17 December 2025

Ritu Shankar
Department of Planning, Housing and Infrastructure

Request for Advice – Exhibition of SSD-96272465, Residential Flat Development at 11-23 Rangers Avenue, Mosman

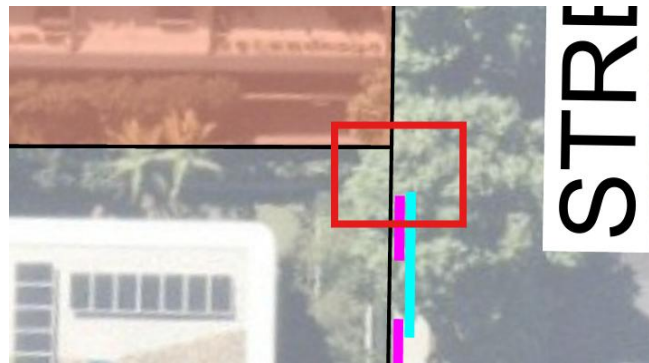
(c) The walking route identified on the Surveyor Walking Map does not touch the mapped town centre as illustrated in the following extract.

(e) However, the path of travel (Walking Route 2) which is the shortest distance nominated by the Applicant is not a route that may be safely walked by pedestrians, as it requires a pedestrian to walk along an L shaped section of Bardwell Lane and Bloxsome Lane at an unsafe location. These lanes are unsafe due to their narrow width, lack of footpath and given all servicing for Rangers Avenue occurs along Bloxsome Lane with garbage trucks required to reverse from the eastern most end of Bloxsome Lane to Bardwell Lane. It is noted that the pedestrian

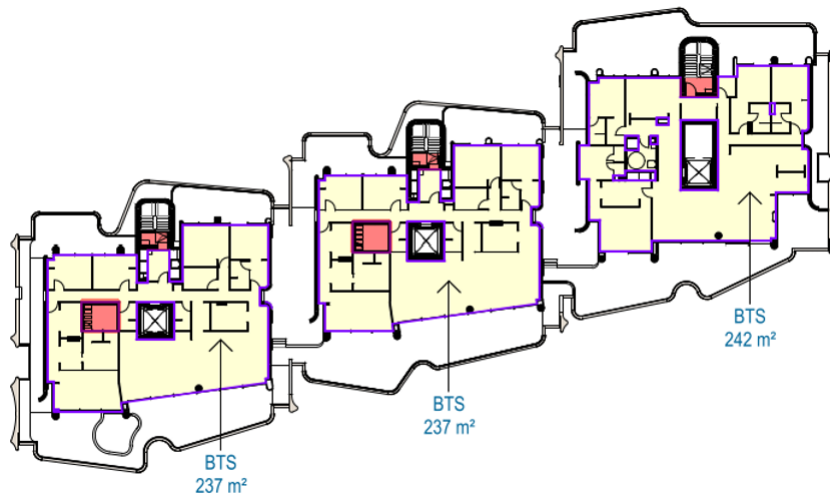
- (c) As defined under Section 15B of SEPP (Housing) 2021, the affordable housing component of a development means the percentage of the gross floor area used for affordable housing. The affordable housing component of the proposed development includes portions of the service rooms on Levels 1 to 5, which are not exclusively for the purposes of affordable housing as shown in the following extract from Drawing DA5001 with the portion of the service room allocated as part of the affordable housing component on Level 1 shaded in red:

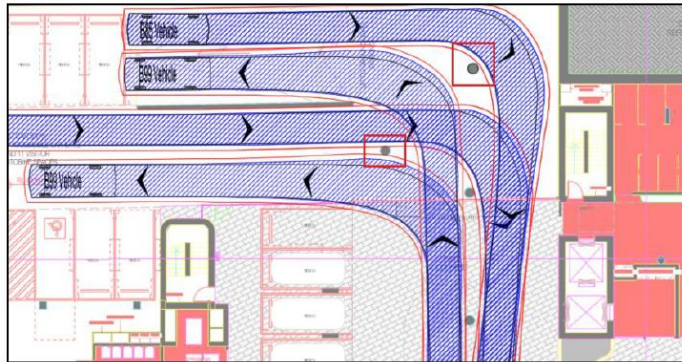
(b) Pedestrian Sight Splays have not been provided for the driveway exiting the property in accordance with Figure 3.3 of AS2890.1.

31. To improve safety, the driveway exiting the property shall be modified to provide adequate sight distance. Modified plans as required shall be submitted with the Construction Certificate and certified by a qualified engineer or architect as complying with "Australian Standard/New Zealand Standard 2890.1 Parking Facilities – Off-Street Car Parking".

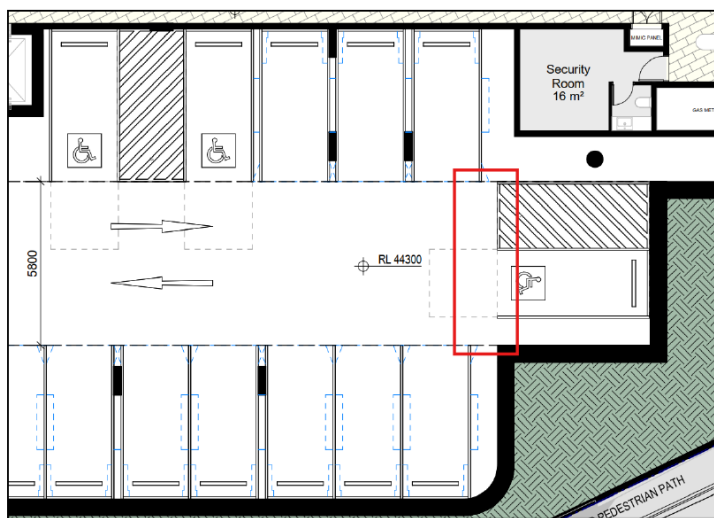
(d) A column has been placed nearly opposite the first visitor parking bay on the Lower Ground Floor, within the 5.8m parking aisle, and is a likely collision hazard.

(e) Clause 2.4.2 of AS2890.1 has not been satisfied, whereby a 1m aisle extension has not been provided at the blind aisle on the Lower Ground Floor Level as shown red in the extract below:
